COTTAGE HILL PLACE SUBDIVISION

APPLICATION NUMBER 7 DATE October 6, 2016

DETAIL SITE PLAN

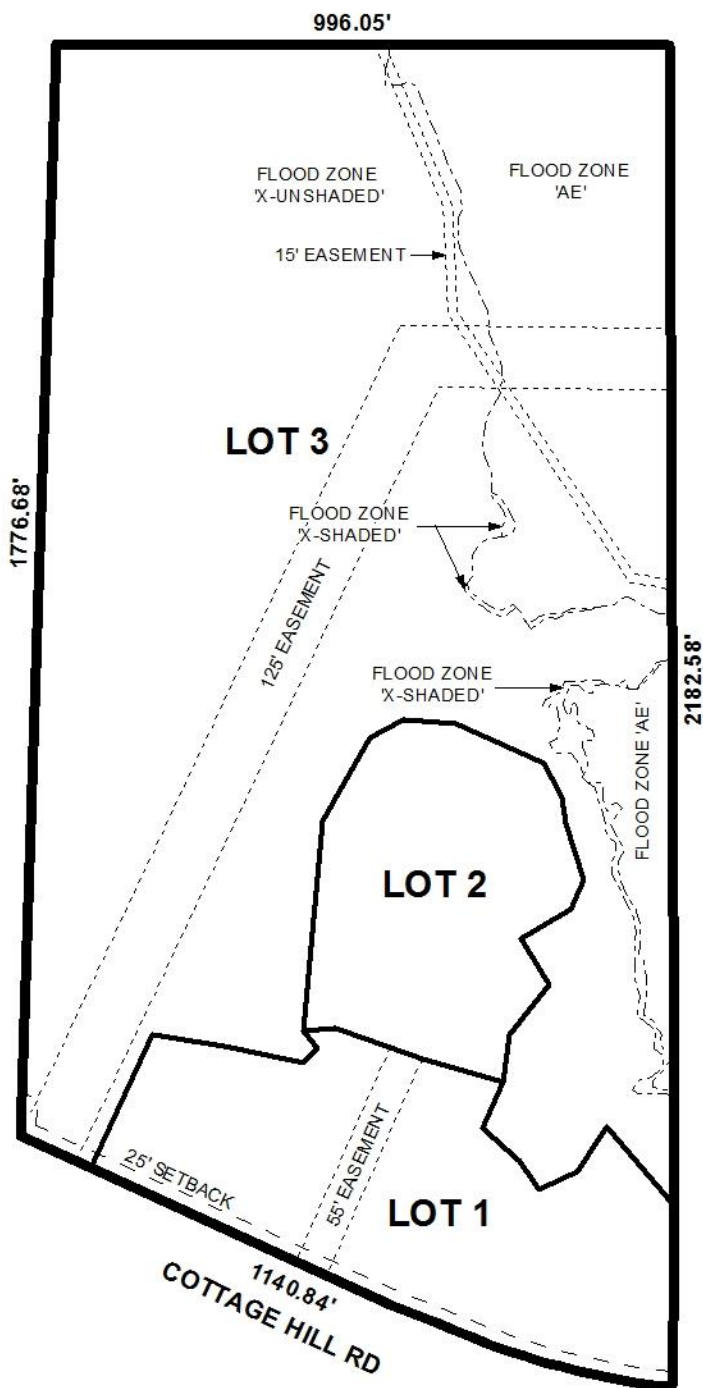
The site has frontage along Cottage Hill Road which is a component of the Major Street Plan with a planned 100' right-of-way. As the plat indicates a variable right-of-way width ranging from 50' to 55' from the centerline, no dedication would be required. As on the preliminary plat, the 25' minimum building setback line should be retained along Cottage Hill Road for Lots 1 and 3 on the Final Plat. As proposed Lot 3 has frontage on the street stub of Aspen Drive on its Western boundary and Sequoia Drive North at its Northwest corner, a 25' minimum building setback line should be blocked-out at the terminus of the Aspen Drive street stub and at the corner abutting Sequoia Drive North. A 25' minimum building setback line should be illustrated on Lot 2 as measured from its South line at the access easement.

As proposed Lot 1 would have slightly over 1,000 linear feet of street frontage along Cottage Hill Road, a note should be placed on the Final Plat stating that Lot 1 is limited to two curb cuts to Cottage Hill Road, with the size, location and design to be approved by Mobile County Engineering and conform to AASHTO standards. A note should also be required limiting Lot 3 to one curb cut to Cottage Hill Road. If Lot 3 is developed commercially, a note should be required on the Final Plat denying access to Aspen Drive unless access is required for International Fire Code compliance. Access to Lot 2 is proposed via a 55' easement across Lot 1 from Cottage Hill Road.

The proposed lots meet the minimum size requirements of the Subdivision Regulations. As on the preliminary plat, the lot sizes in both square feet and acres should be retained on the Final Plat, or a table should be furnished on the Final Plat providing the same information.

As proposed, all lots are of irregular shape. However, Section V.D.1. of the Subdivision Regulations allows for such under certain unusual circumstances, including natural barriers which may cause an undue hardship on the land owner. The site contains approximately 19.5 acres of meandering wetlands (approximately 41%) and Lots 1 and 2 are arranged so as to maximize the upland acreage. Lot 3 is configured to contain all of the wetlands and associated flood zones. Therefore, a waiver of Section V.D.1. would seem in order. Lot 3 would also require a waiver of Section V.D.3. for its width-to-depth ratio and this would also seem in order. As Lot 2 would not have direct public street frontage, a waiver of Section V.D.4. would be required. However, it appears that lot lines could be reconfigured to provide Lot 2 with real frontage onto Cottage Hill Road. Doing so may require creating two lots from proposed Lot 1.

The plat indicates a 100' Alabama Power Company easement running across the site; the 55' access and utility easement from Cottage Hill Road to Lot 2; and a 15' sanitary sewer easement in the Northeast portion of the site. Therefore, a note should be required on the Final Plat stating that no structures may be placed or constructed within any easement.

While the site is in Mobile County, it will have to comply with the City of Mobile storm water and flood control ordinances. A note should be placed on the Final Plat stating that the development will be designed to comply with the storm water detention and drainage facility requirements of the City of Mobile storm water and flood control ordinances, and requiring submission of certification from a licensed engineer certifying that the design complies with the storm water detention and drainage facility requirements of the City of Mobile storm water and flood control ordinances prior to the issuance of any permits. Certification is to be submitted to the Planning Section of Urban Development and County Engineering.

A note should be placed on the Final Plat stating that if the site is developed commercially and adjoins residentially developed property, a buffer must be provided in compliance with Section V.A.8. of the Subdivision Regulations.

Due to the fact that Lot 2 would be land-locked and there appears to be sufficient area to provide Lot 2 with real frontage onto Cottage Hill Road, it is recommended that this application be heldover to the November 3rd meeting to allow the applicant to revise the plat to provide real frontage onto Cottage Hill Road for Lot 2. Revisions should be submitted to Planning no later than October 17th.
